Lahore Water and Wastewater Management
Project (LWWMP)

Minutes of 1st Pre-Tender Meeting

**LAHORE WASTEWATER AND DRAINAGE MANAGEMENT
PROJECT (LWDMP) - SEWERAGE SYSTEM FROM LARECHS
COLONY TO GULSHAN E RAVI, LAHORE (THROUGH
TRENCHLESS TECHNOLOGY)**

**LAHORE WASTEWATER AND DRAINAGE MANAGEMENT PROJECT (LWDMP) –
SEWERAGE SYSTEM FROM LARECHS COLONY TO GULSHAN-E-RAVI LAHORE
MINUTES OF 1st PRE-TENDER MEETING HELD ON 30/10/2025 AT 1500 HRS
IN COMMITTEE ROOM, WASA HEAD OFFICE**

| | | REV. | DATE | DESCRIPTION | APPROVED | | DRAWING No. LW-TD-005A |

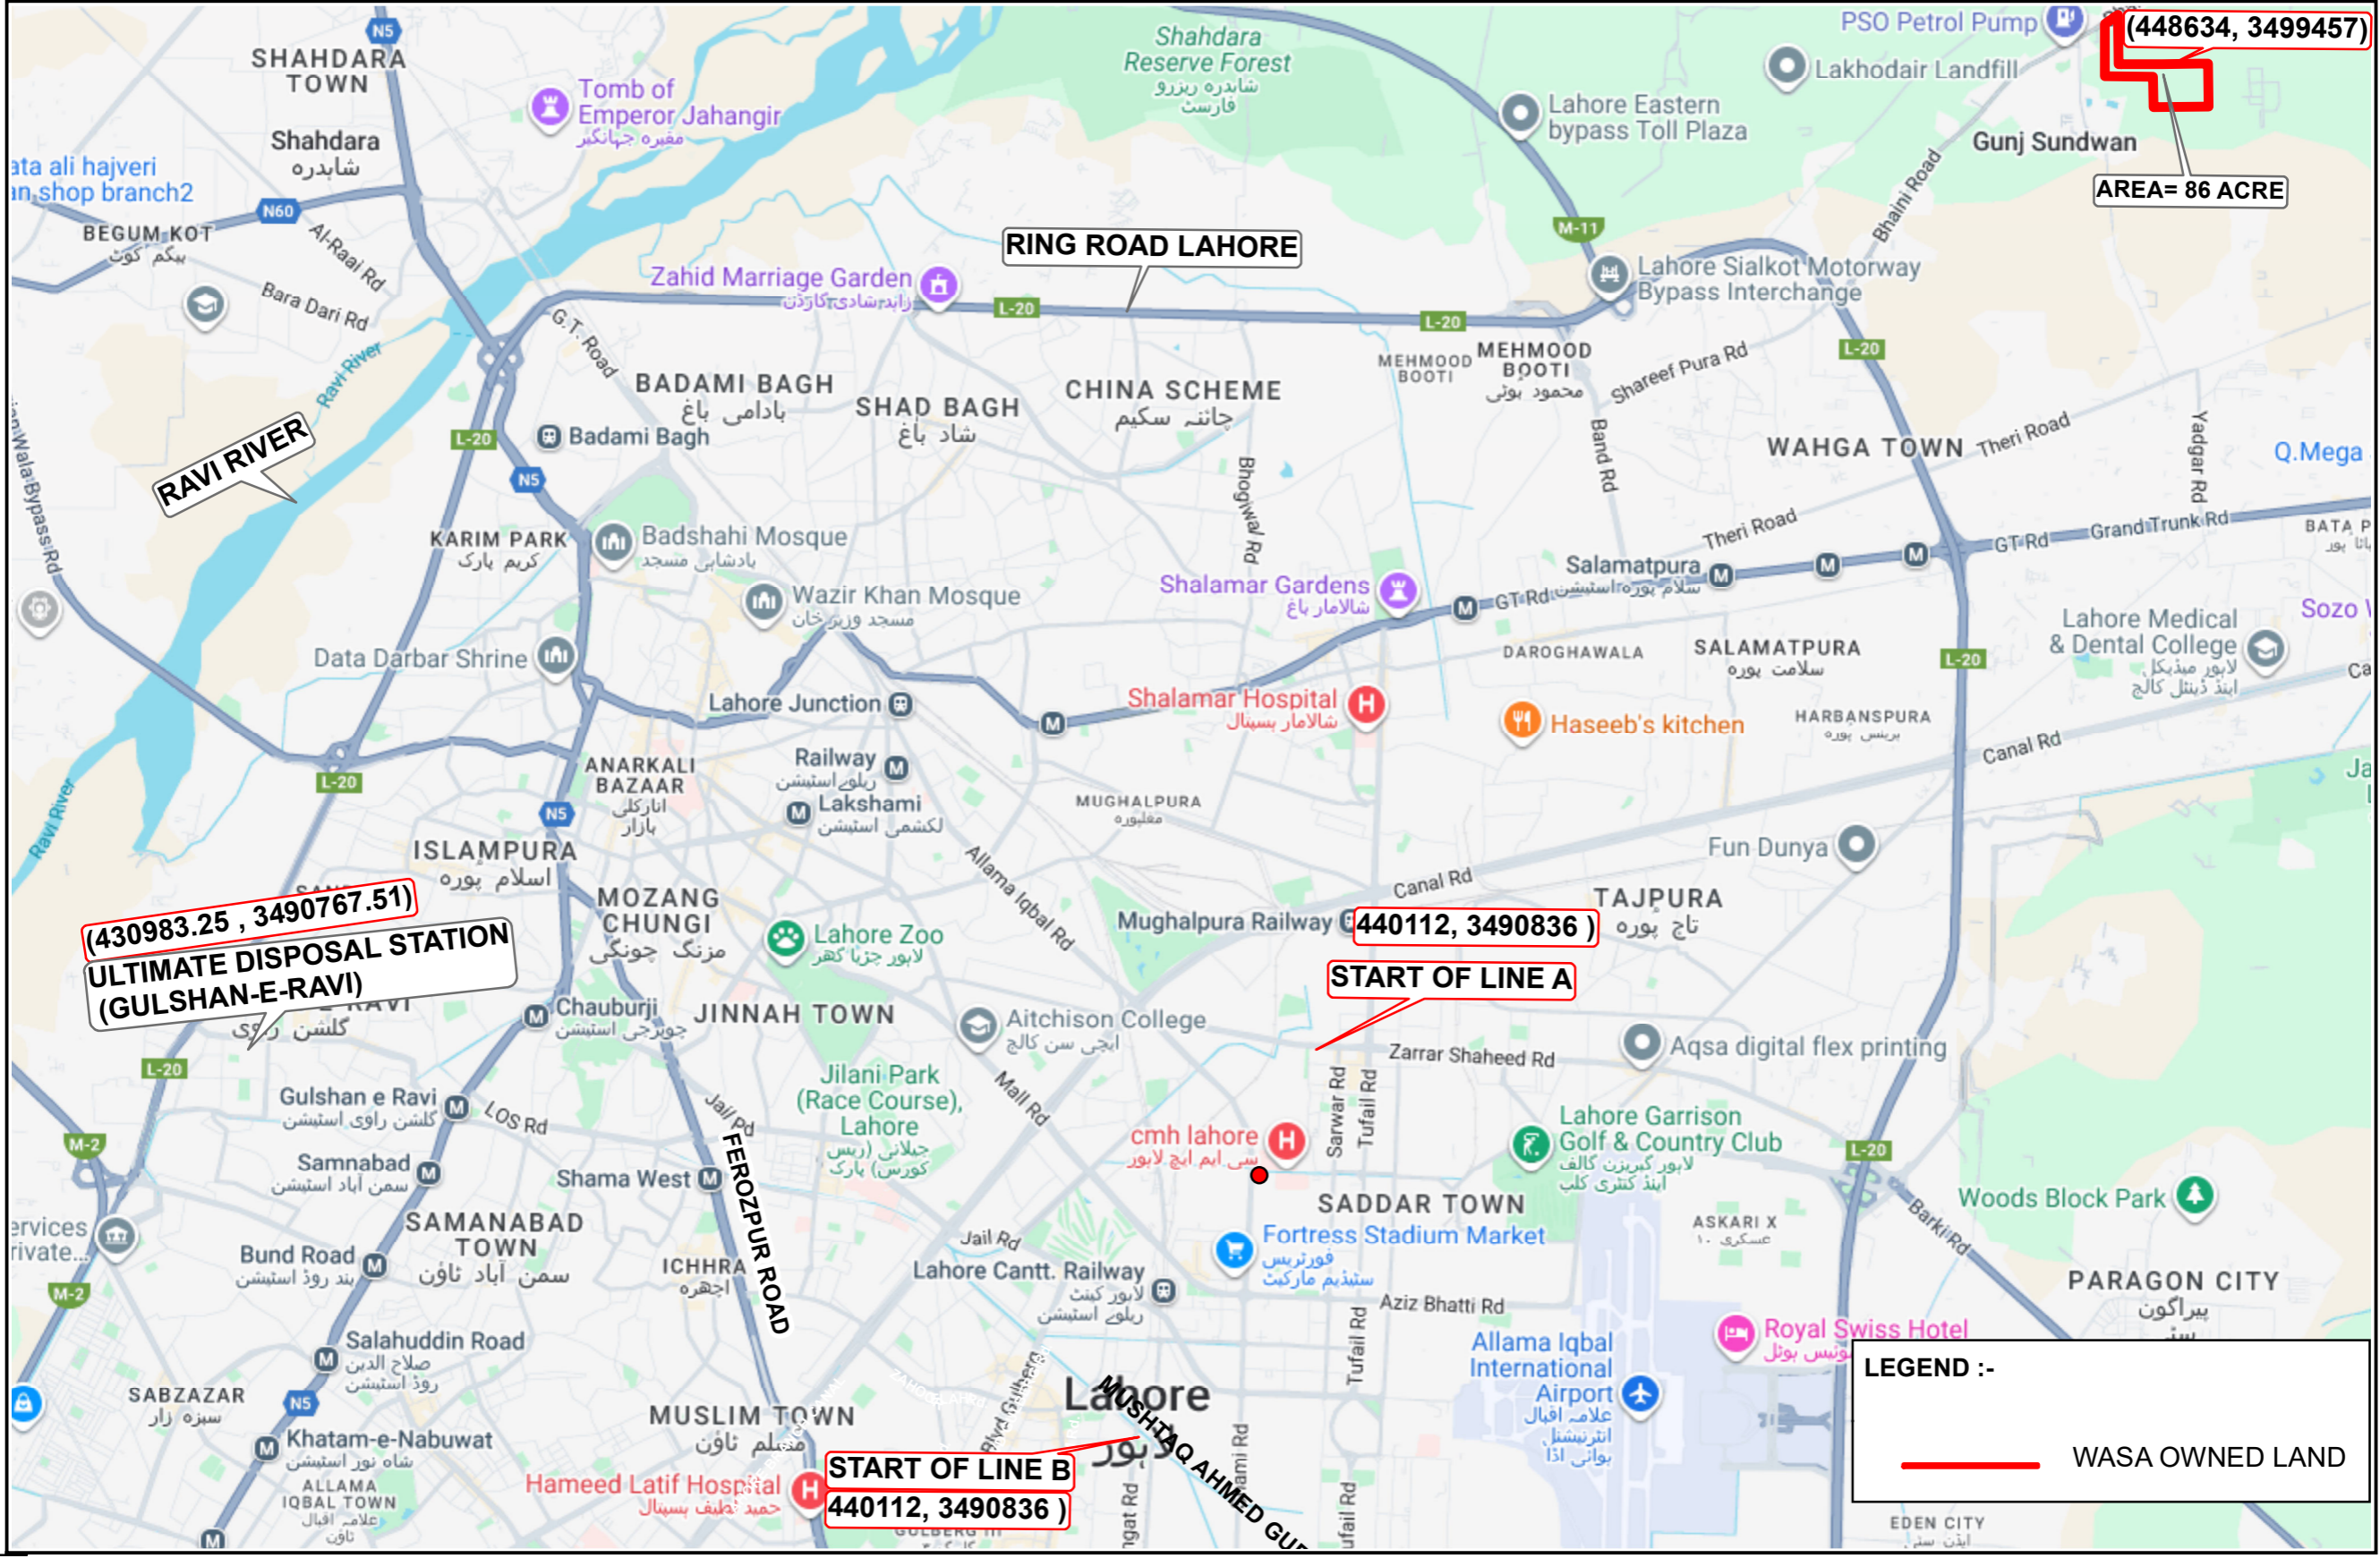
| Sr # | Reference Section | Queries | Employer's Response |
|------|--|---|---|
| 5. | Volume 3, Part II, Section 6, Employer's Requirement | The location for disposal of debris, muck, and slurry has not been specified. Kindly specify the designated disposal site, as the lead distance for transportation depend on this information. | <p>The designated location for disposal of debris, muck, and slurry has already been indicated in Drawing No. LW-TD-005. This land can also be used for Camps.</p> <p>It is further clarified that the WASA-owned land indicated near Ferozepur Road in Drawing No. LW-TD-005A is no more available for Contractor's use, whereas an alternate land located at Bhaini Road can be made available (subject to site clearance and preparation by the Contractor). However, the Contractor may propose any Government Owned Land for its use subject to its availability, for which the Employer may provide reasonable assistance to in providing the land for intended purpose through coordination with the respective department. In case, no suitable land is provided for camps and labour, material / equipment, pipe manufacturing facility by the Employer, the Contractor shall arrange the land through its own means and costs.</p> <p>The updated Drawing of WASA owned land (LW-TD-005A) at Bhaini Road is attached as Annexure-A.</p> <p>An addendum will be issued reflecting the above.</p> |

| <p>WATER AND SANITATION AGENCY, LAHORE</p> <p><i>A Joint Venture</i></p> | 04 | | | DRAWN | MUHAMMAD HAMMAD NASEER | <p align="center">ULTIMATE DISPOSAL STATION MASTER LAYOUT PLAN PUMP HOUSE</p> <p>DATE:- NOVEMBER, 2025</p> <p>DRAWING NO.:- LW - TD - 402</p> |

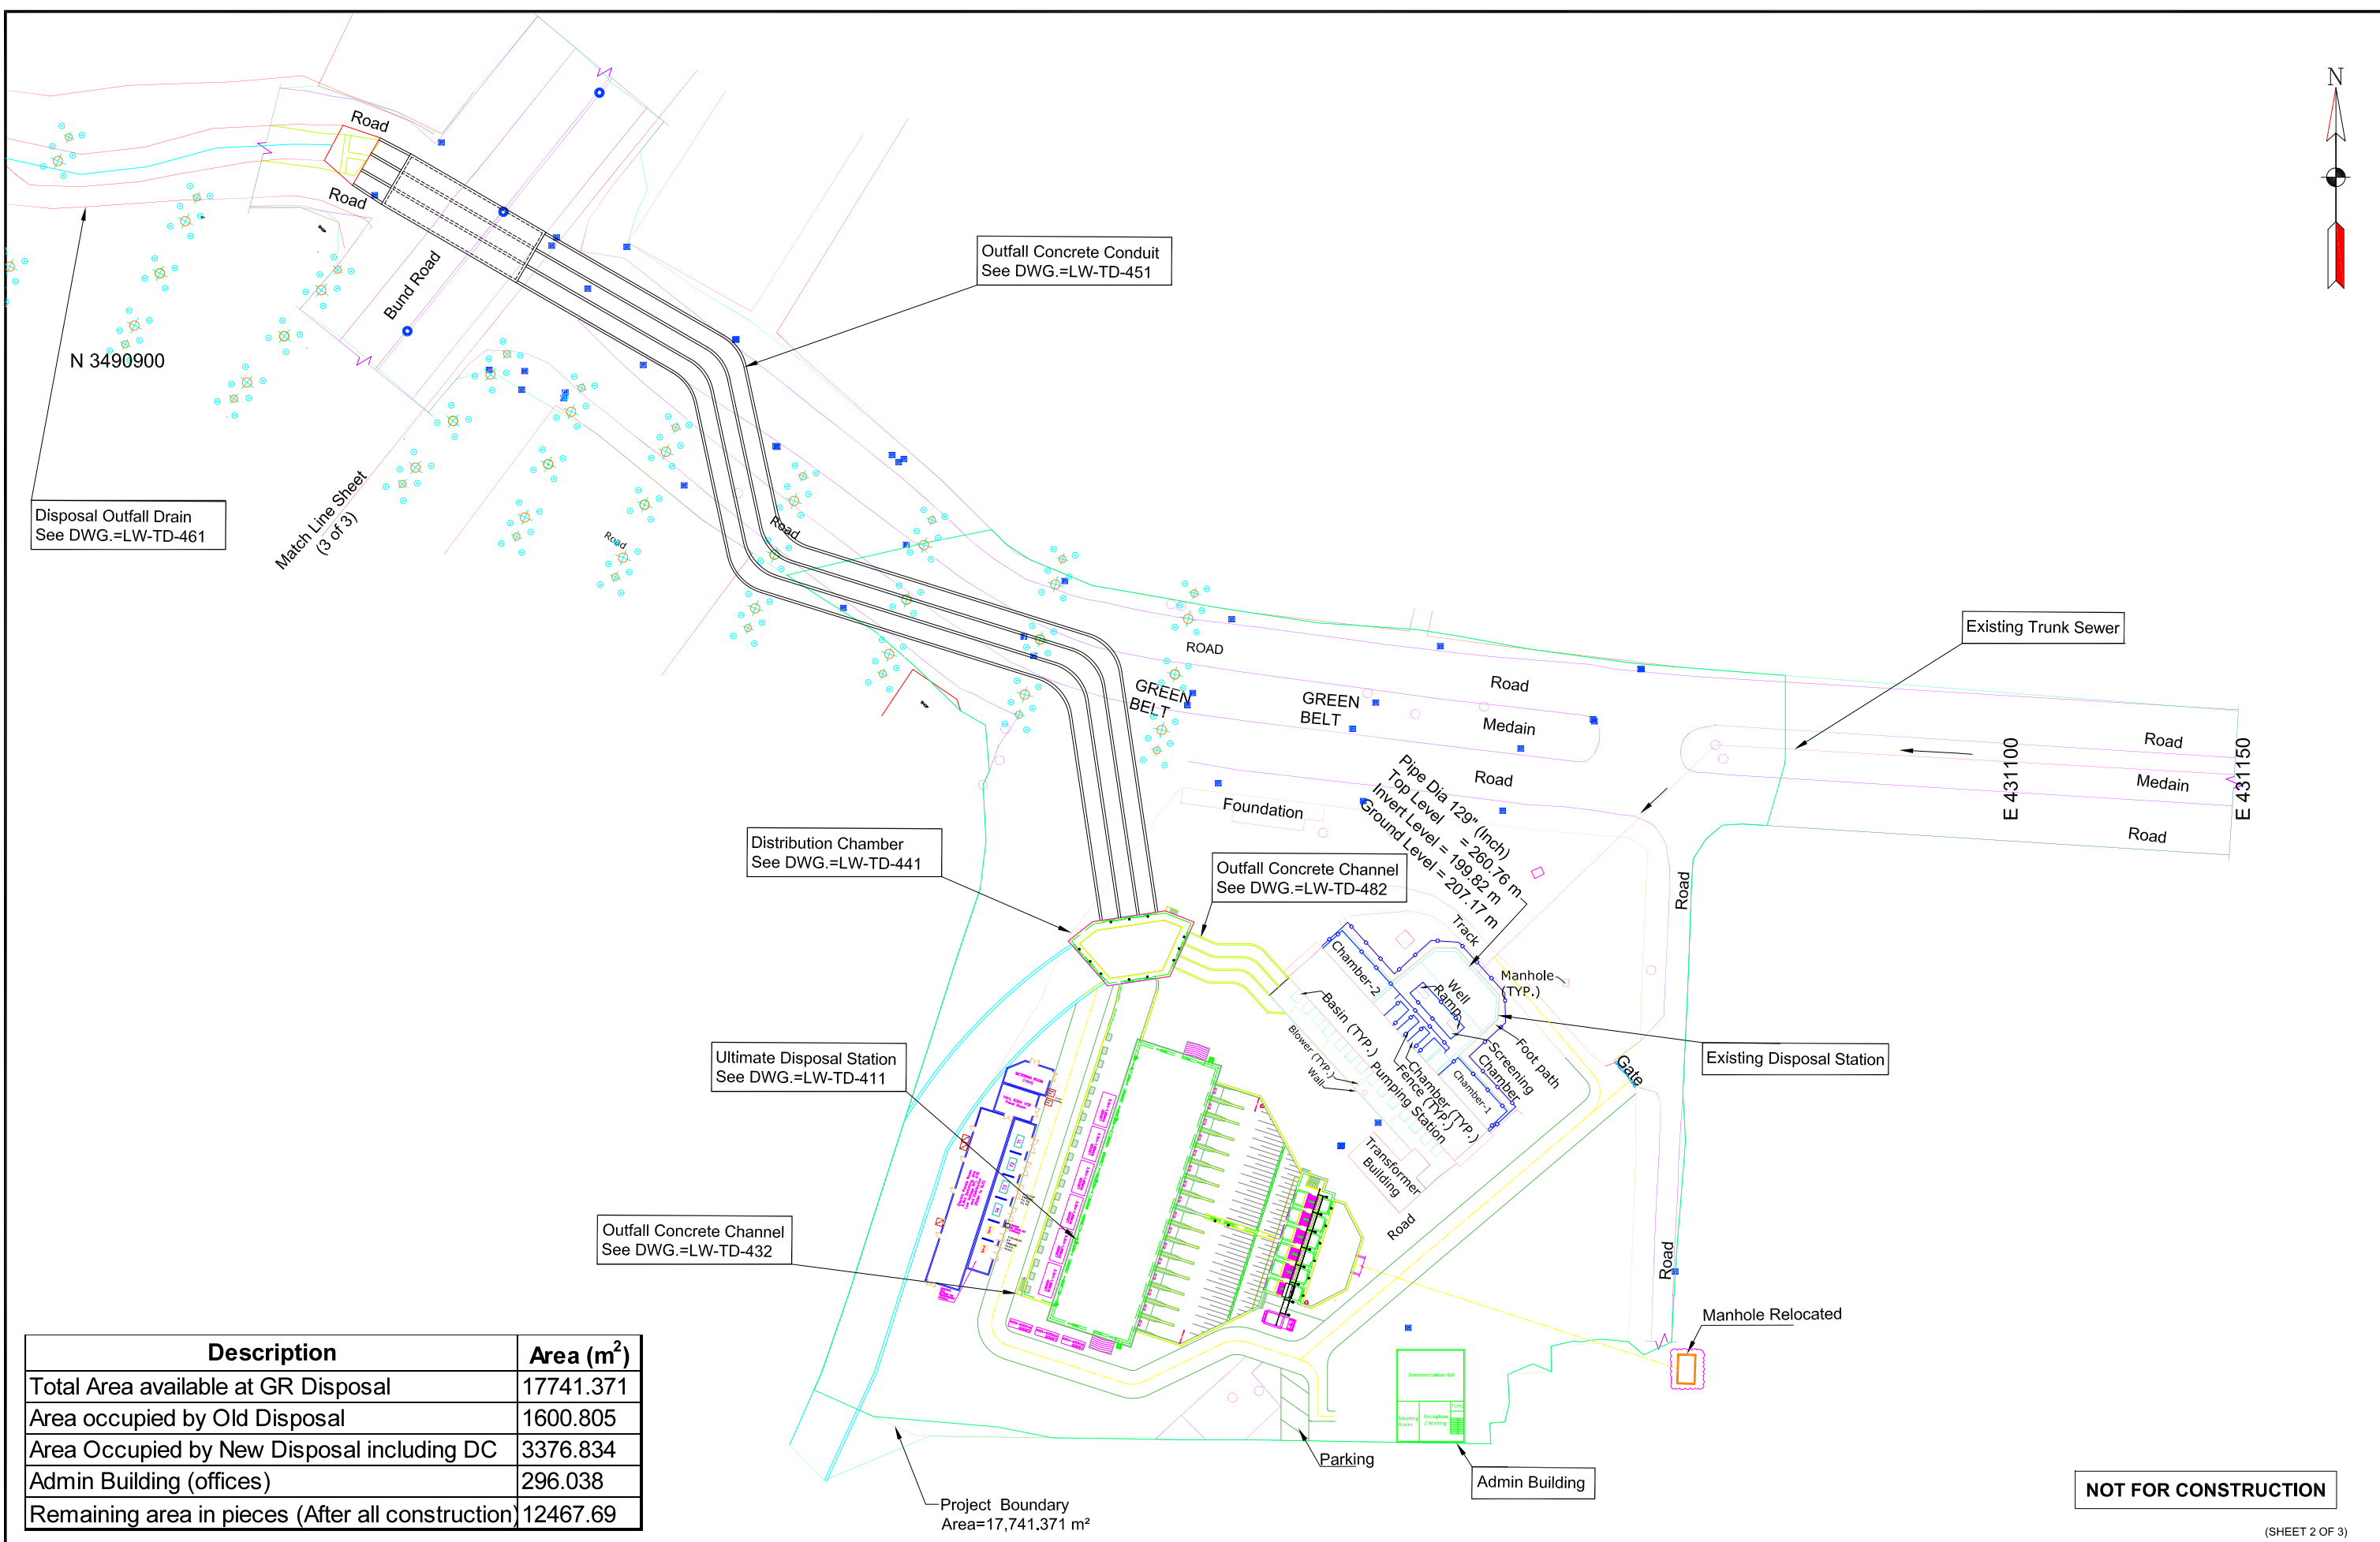
| Sr # | Reference Section | Queries | Employer's Response |
|------|--|---|--|
| 70. | <p>Volume-3, Part II, Section 6 - Employer Requirements, Tender Drawings.</p> <p>Master Layout Plan Pump House (Drawing No. LW-TD-402)</p> <p>Volume-3, Part II, Section</p> | <p>While reviewing both drawings in conjunction, it has been observed that the Admin Building and access roads are overlapping with the electrical buildings / installations.</p> <p>It is the Bidder's understanding that the provision of adequate space for the buildings, equipment, and other infrastructure works included in the Contractor's scope of work shall be the Client's responsibility. Please confirm.</p> | <p>It is to clarify that the updated switchgear and allied electrical installations, including the 132/11 kV grid area, transformers, panels, and trench layout, can be accommodated adjacent to and outside the pump house, as shown in the updated drawings (Drawing Nos. 492 and 493) annexed at Annexure-J.</p> <p>Furthermore, the control room, along with all associated accessories, shall be located on a dedicated floor within the administration/office building.</p> |

| Sr # | Reference Section | Queries | Employer's Response |
|------|--|--|---|
| | 6 - Employer Requirements, Tender Drawings.. 132/11kV Grid Space & Transformers, Panels, Trench Layout (Drawing No. LW-TD-492) | | Adequate space for all required buildings, equipment, and associated infrastructure has already been allocated within the existing Gulshan-e-Ravi Pumping Station premises and is reflected in the tender drawings. No additional land or space allocation shall be provided. |
